Re: Rochester Gas and Electric Corporation
R. E. Ginna Nuclear Power Plant Unit No. 1
Docket No. 50-244

APPLICATION FOR AMENDMENT
TO
OPERATING LICENSE

Safety Evaluation for proposed change to Figure 6.2-1 and
Figure 6.2-2 -- Technical Specifications

Figure 6.2-1

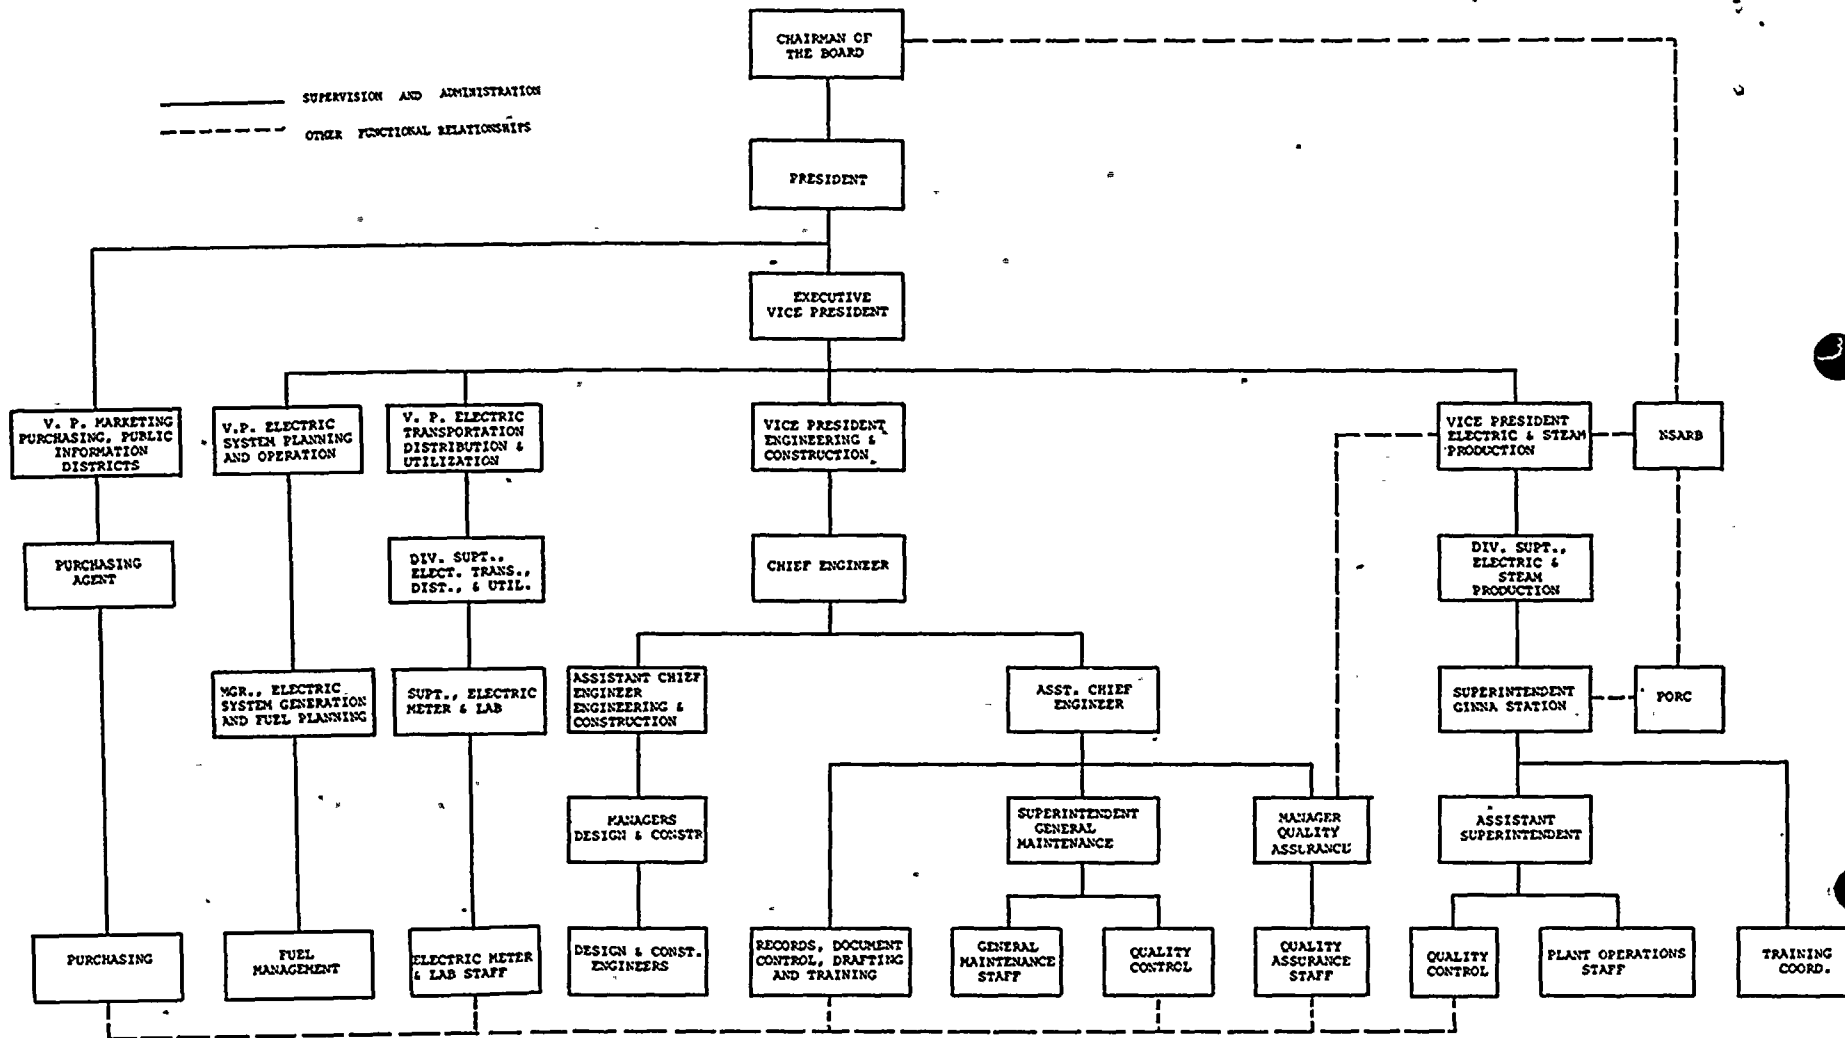
Pursuant to Section 50.90 of the regulations of the Nuclear Regulatory Commission ("the Commission"), Rochester Gas and Electric Corporation hereby requests that the Technical Specifications set forth in Appendix A to Provisional Operating license No. DPR-18 be amended. Specifically, Rochester requests that Figure 6.2-1 and Figure 6.2-2 of Technical Specifications be amended to reflect revisions to the station staff and station management organization.

WHEREFORE, Applicant respectfully requests that Figure 6.2-1 and Figure 6.2-2 of Appendix A to Provisional Operating License No. DPR-18 be amended in the form attached hereto as Attachment A.

The proposed change does not constitute any significant hazards consideration, as the change, which results from recent establishment of new station positions and the assignment of technical support responsibilities to additional Company organizations, does not degrade the management control of Ginna Station.
